Columbia River Crossing Project  
C/O Heather Gundersen, Environmental Manager  
700 Washington Street, Suite 300  
Vancouver, WA 98660

**SUBJECT: URBAN DESIGN ADVISORY GROUP COMMENTS TO THE DRAFT  
ENVIRONMENTAL IMPACT STATEMENT**

DRAFT -Design Guidance for the Columbia River Crossing Project

#### Exhibit 3-6. North Bank & SR 14 Interchange

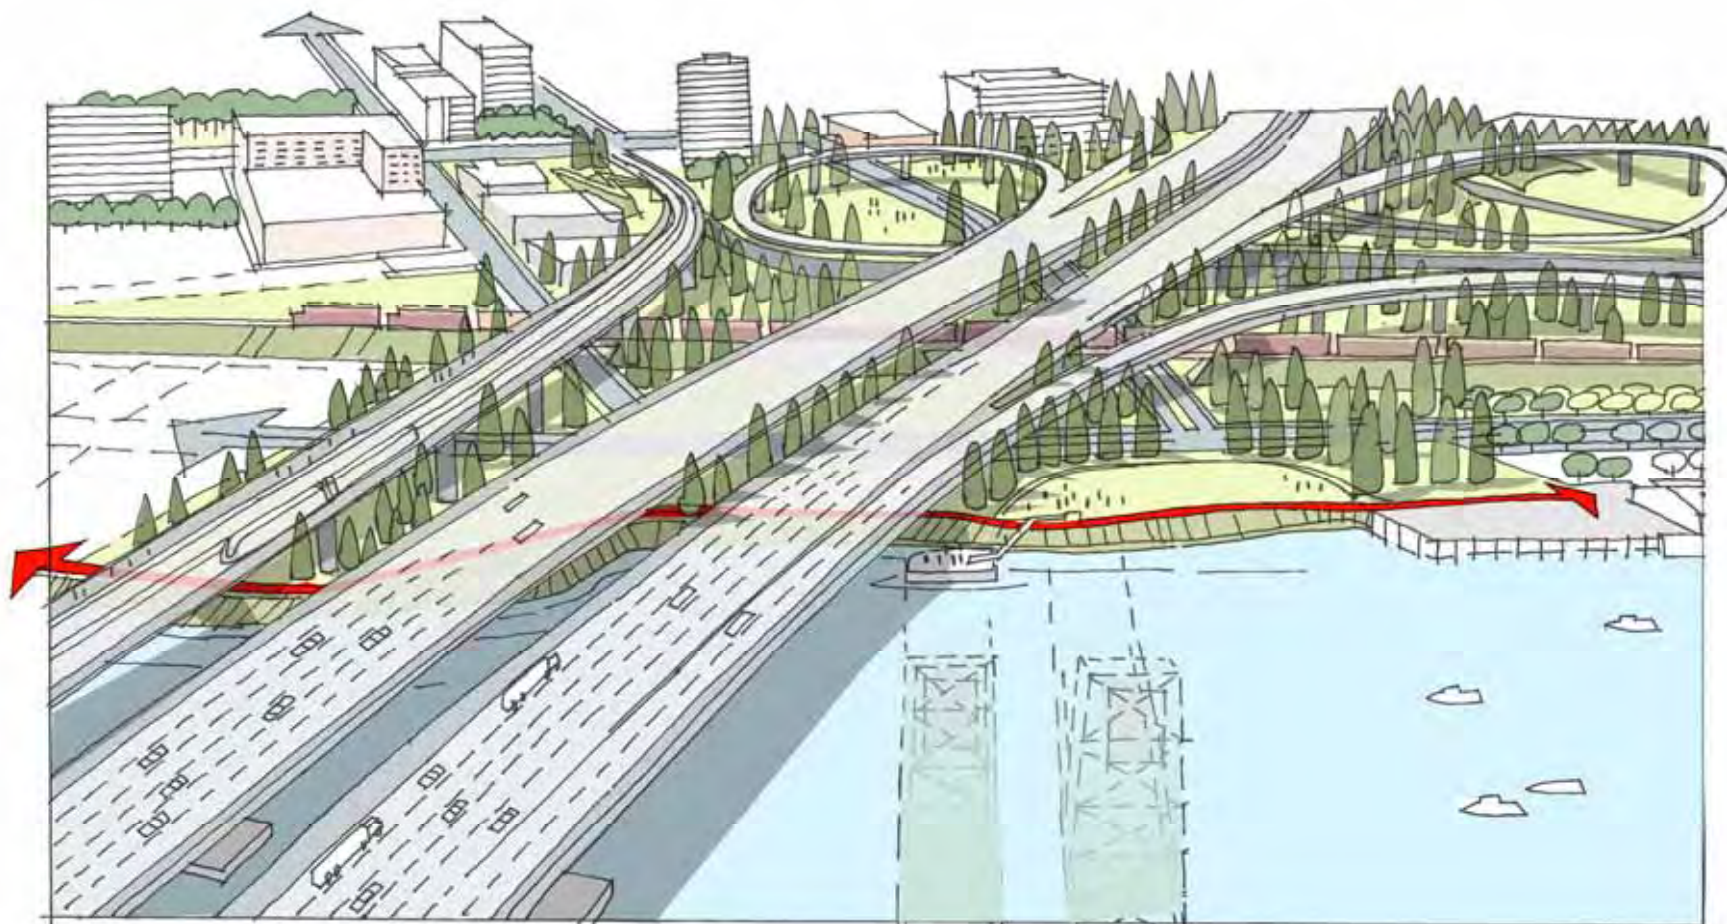
23. Redesign the river bank at the former bridgehead under I-5 and the Red Lion site as urban park space in which people can meet, enjoy views, and otherwise use this shoreline destination. *Reconfigure the under-bridge as destination public open space.*

24. Investigate options for regrading and redesign of the river bank under the highway, including options for retention of fragments of the old bridges. *Investigate different under-bridge designs*

25. Designate a continuation of the regional trail through this space. *Include continuation of the waterfront trail.*

30. Connect the Land Bridge and Apple Tree Park with downtown Vancouver by combining improved sight lines, improved access and integrating landscape design. *Provide visual and physical connections between under-bridge structures.*

31. Extend landscape treatment associated with the Land Bridge all the way to the river via the BNSF underpass. Also provide a landscaped trail to Main Street extended south to Columbia Way. *Extend Land Bridge landscaping under the bridges.*

32. Design open space within the SR 14 interchange to treat but not detain storm water runoff, reduce broadcast of traffic noise, integrate structures into the landscape, accommodate active open space and provide integral security for structures. *Introduce active and functional uses under the SR 14 interchange.*

Exhibit 3-8. Seventh Street Footbridge

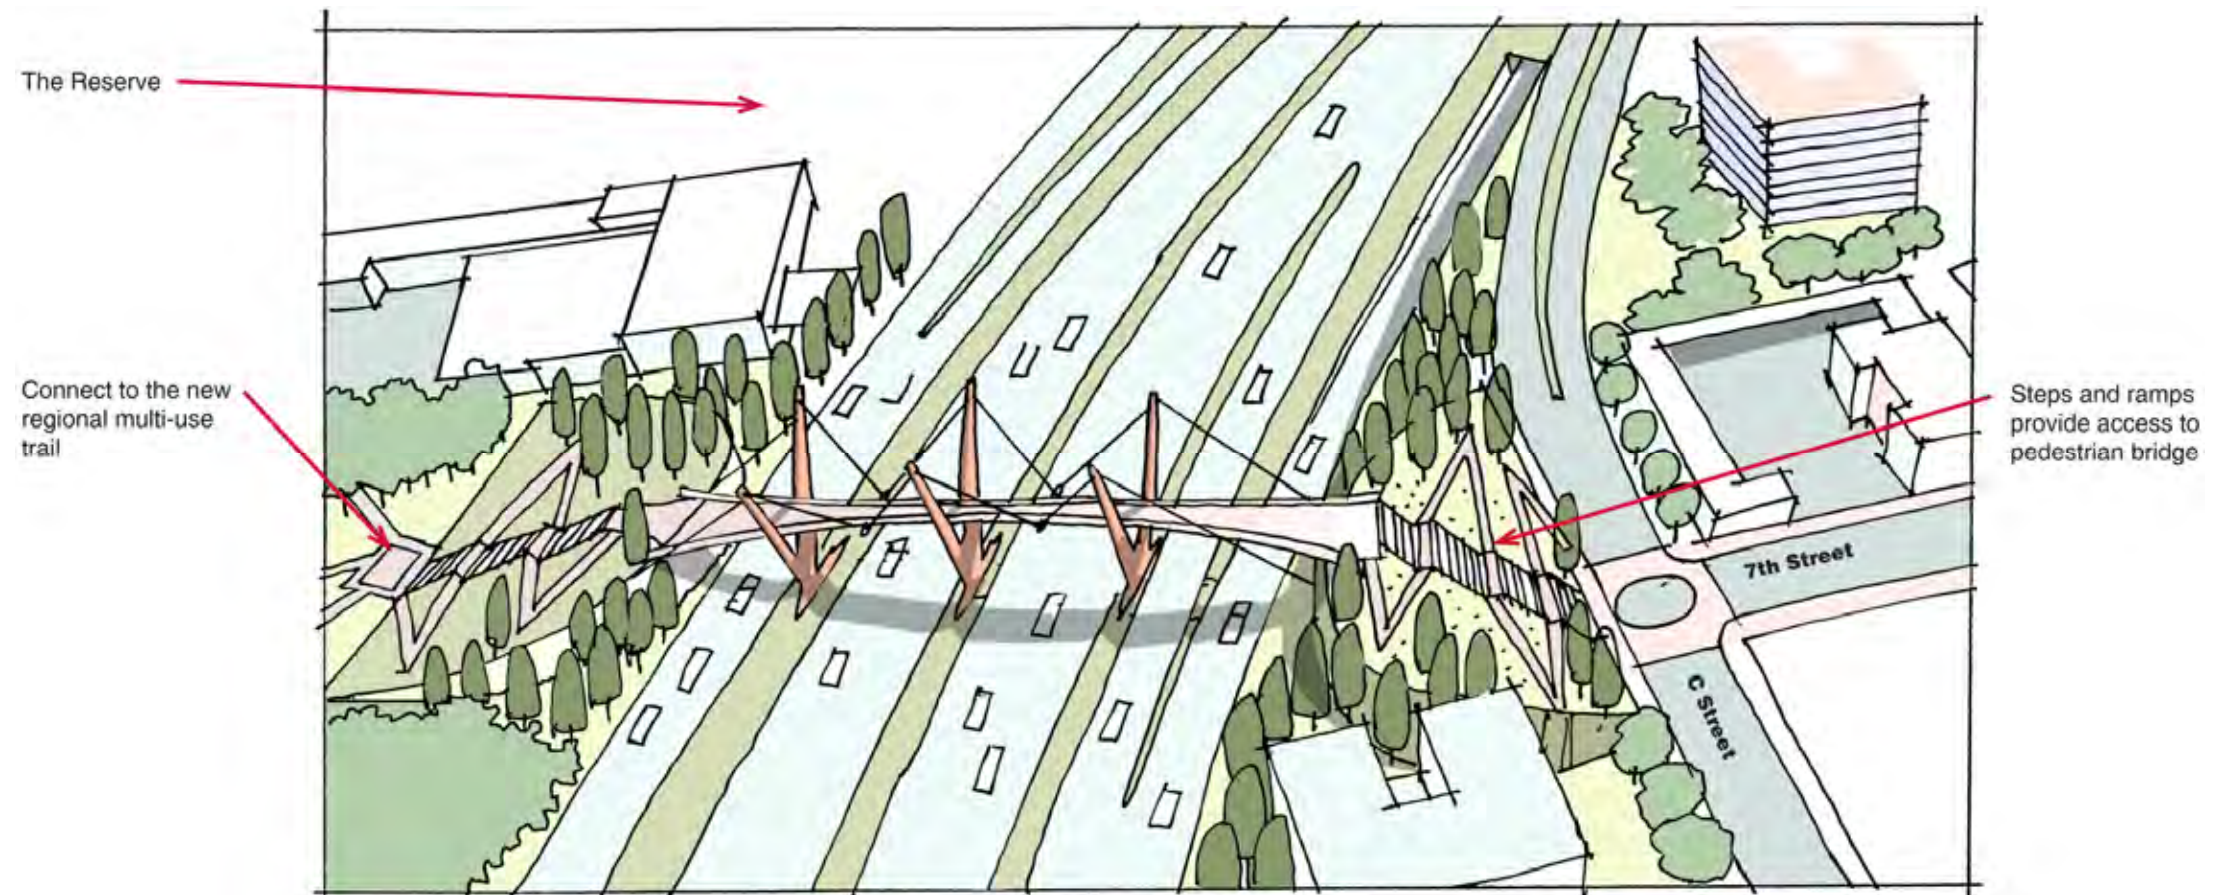
34. Consider the design of the 7th Street footbridge as an opportunity to announce approach to the bridge with an elegant and colorful structure. *Make the footbridge a colorful gateway.*

35. All of the Downtown highway crossings should be addressed functionally and visually as an integrated system. *Consider the collective appearance and function of Downtown crossings.*

**Exhibit 3-10. Mill Plain Interchange****3.2.9 Mill Plain Interchange**

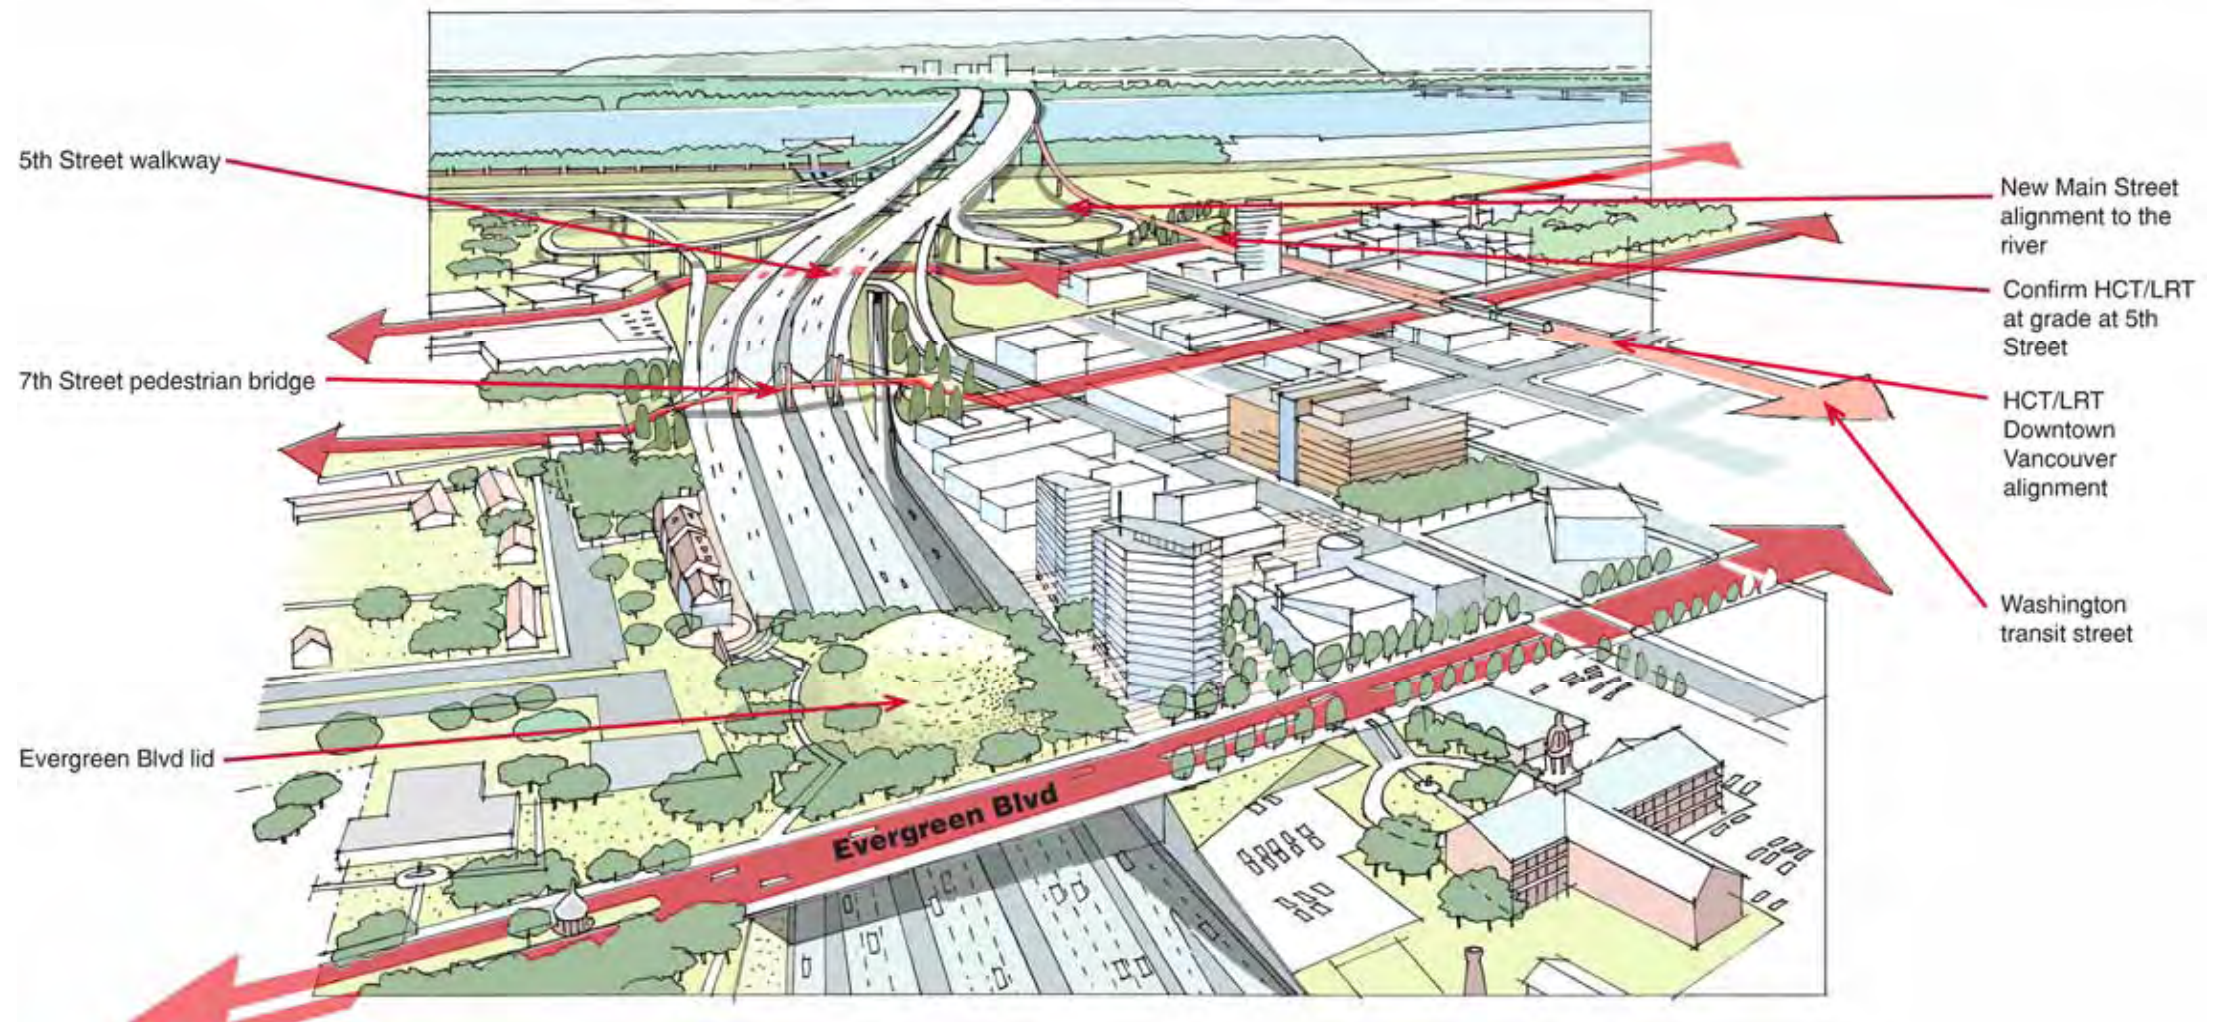
38. Acknowledge through urban design and landscape that Mill Plain is the principal point of access to Downtown from the north and east. *Distinguish the Mill Plain interchange as the principal entrance to Downtown.*

39. Provide safe and direct passage for pedestrians and cyclists on Mill Plain Blvd traveling between destinations east and west of I-5. (The current design appears to address only vehicular traffic needs. Prepare another design that accommodates all modes equitably). *Improve pedestrian and bicycle safety under I-5.*

43. Provide east-west passage for all modes that improve safety and convenience over existing access. *Accommodate transit, pedestrians, bicycles and local vehicular traffic.*

Exhibit 3-11. McLoughlin Boulevard Crossing

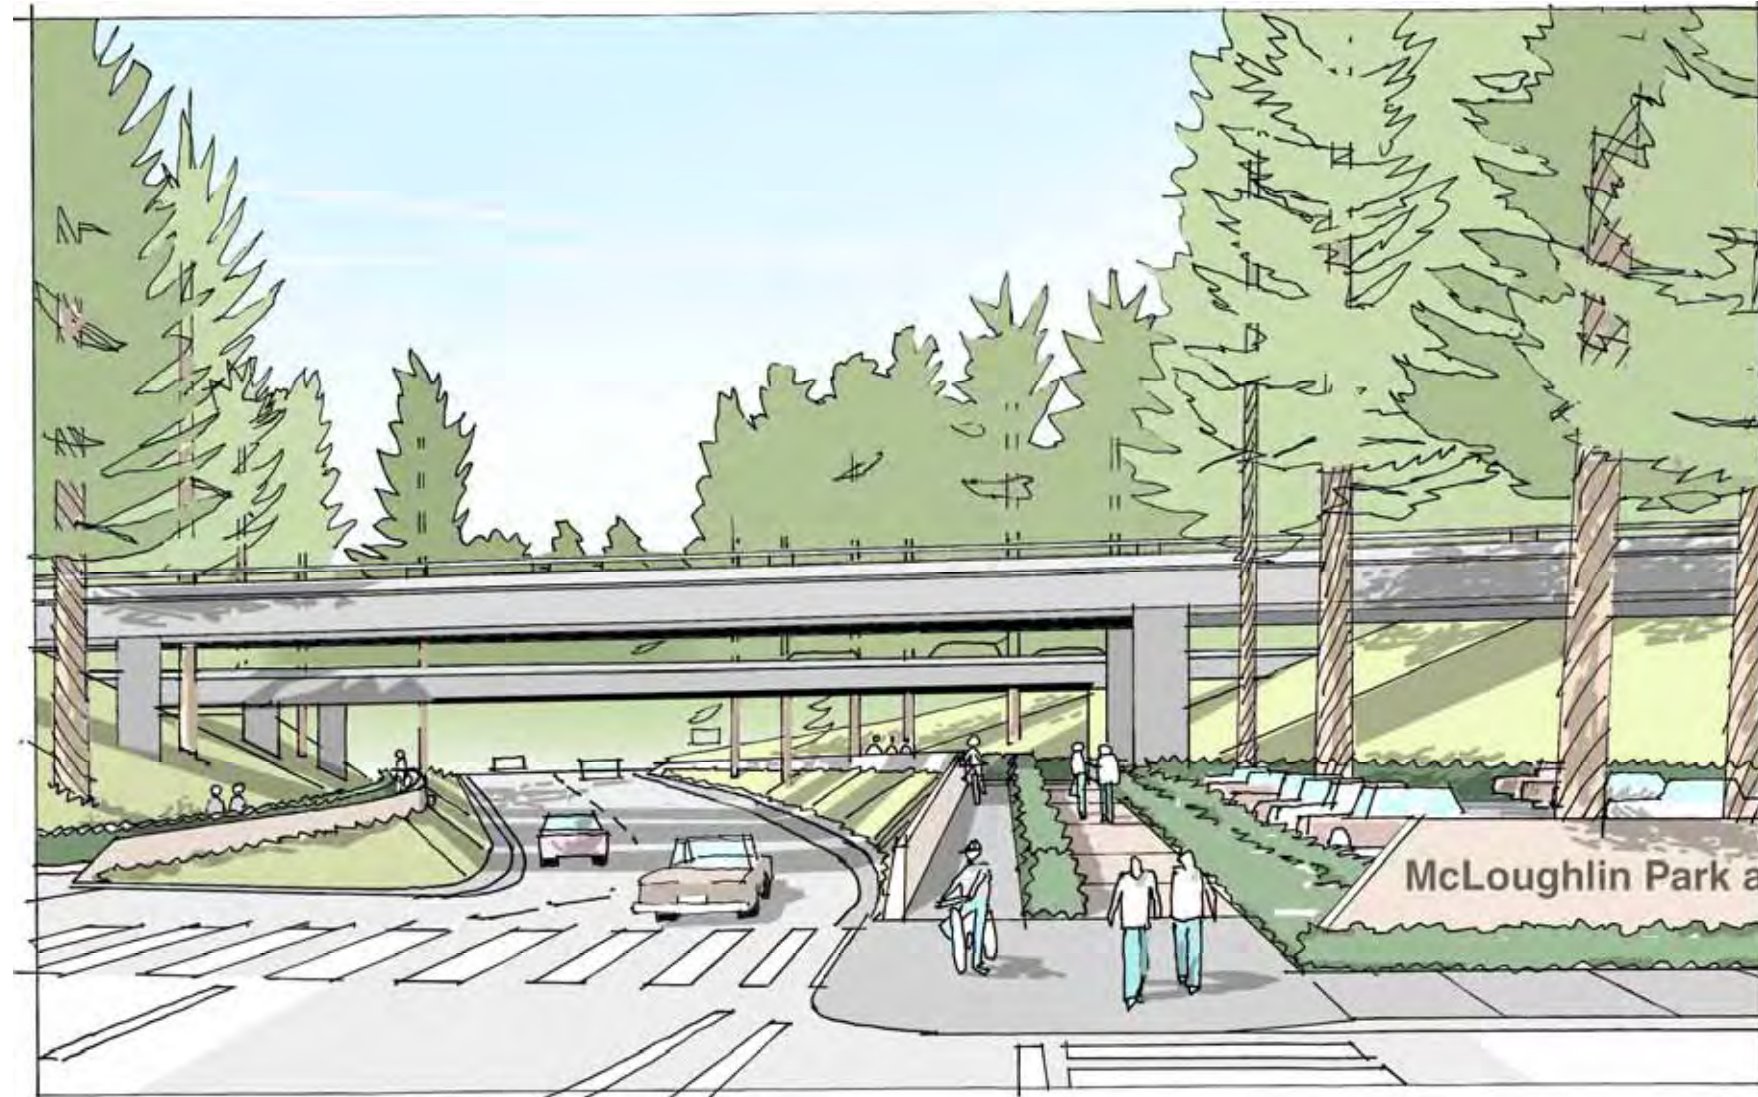
45. Provide sidewalk access along the north side of Fourth Plain adjacent to the cemetery (as stipulated by the Vancouver Central Park policy document). *Improve sidewalks on both sides of Fourth Plain overpass*
